LHC Collimation PHASE II

4th Design Meeting - 14/03/2008

2. Follow up of design solutions (A. Bouzoud)

Figure 3: Cooling circuit on the jaw base has been split in two parts.

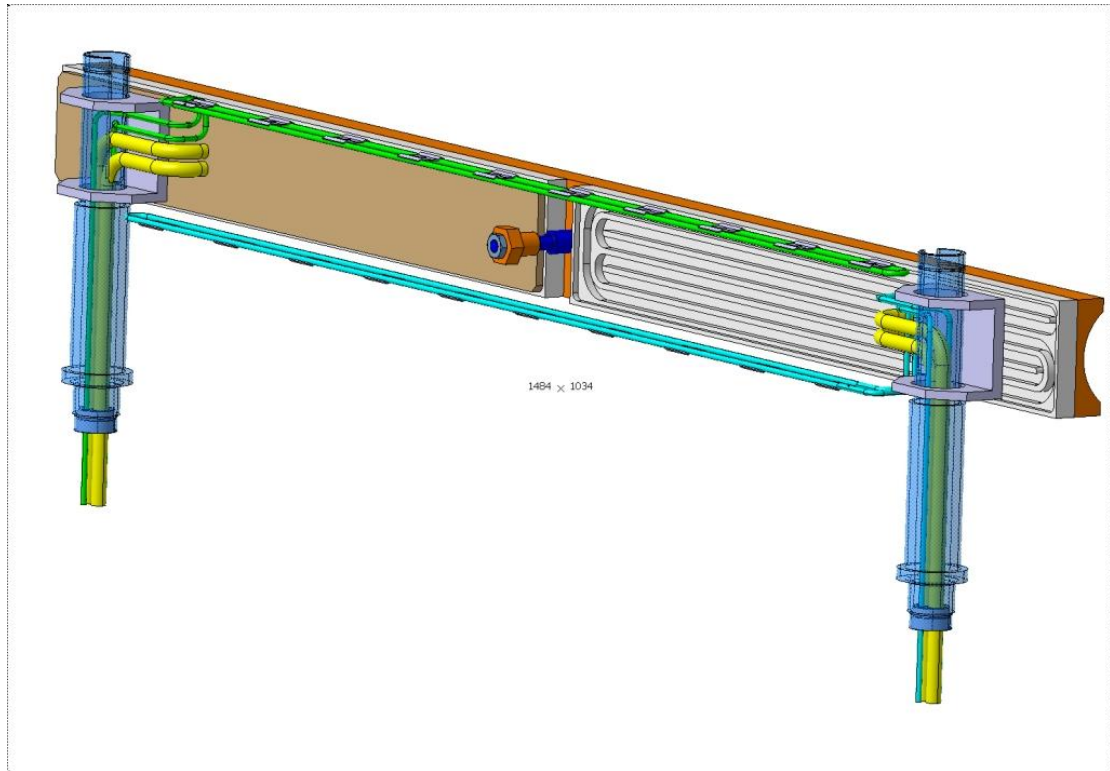
Cooling circuit has been split into two parts on the jaw-base. Dimensions of cooling grooves have been changed (6 X 8mm); also the circular cooling tubes have been enlarged (inner diameter: 8mm). A smaller cooling circuit was also added in order to obtain thermal stabilization of the c-shaped beam; clamping system of this circuit must be studied.

Figure 5: Control system at the middle of the jaw assembly

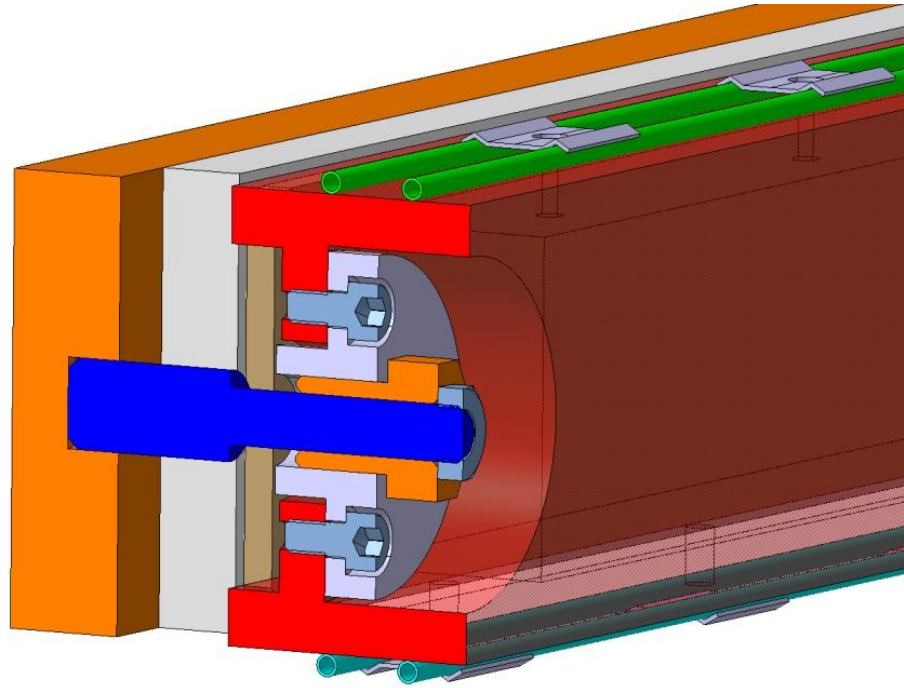
The “weak point” at the middle of the jaw-base must be modified in order to increase the flexibility of the structure. See the following pictures showing some details of the design solutions.

Figure 6: c-shaped beam

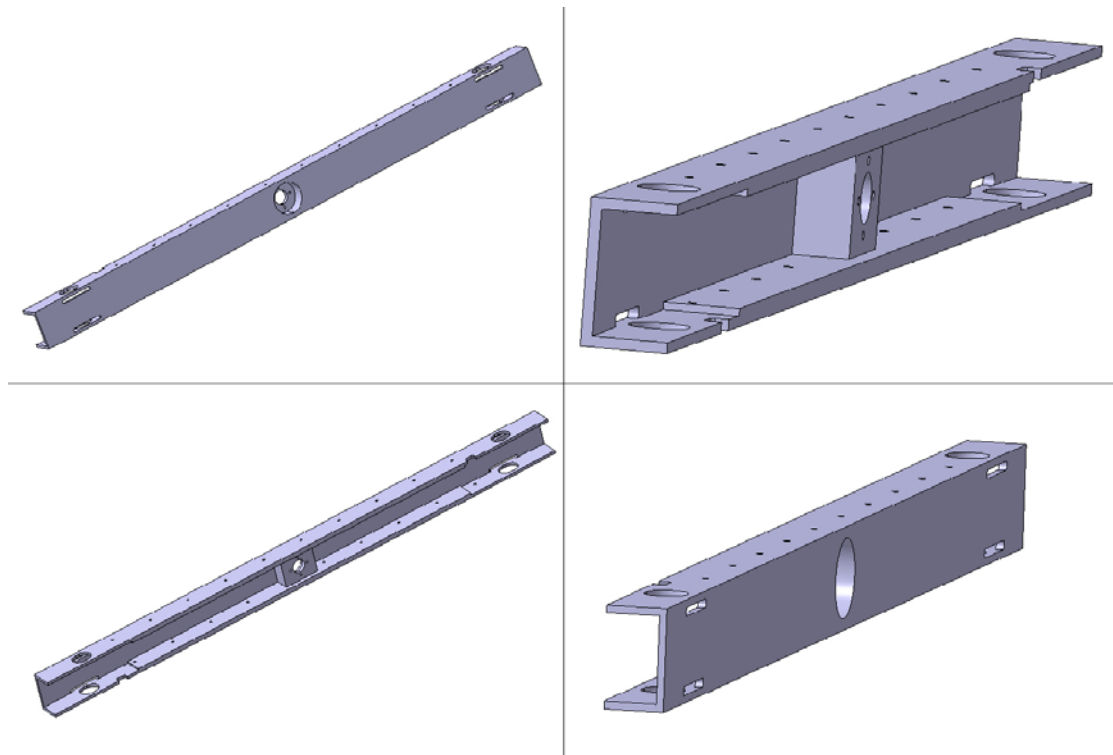
It was proposed to use *Mo* only for the c-shaped beam, where no welding or brazing are necessary, and not for the jaw-base. *Favre* also remarked that the machining of large *Mo* components is quite difficult; furthermore, *Mo* is expensive (260 €/kg).
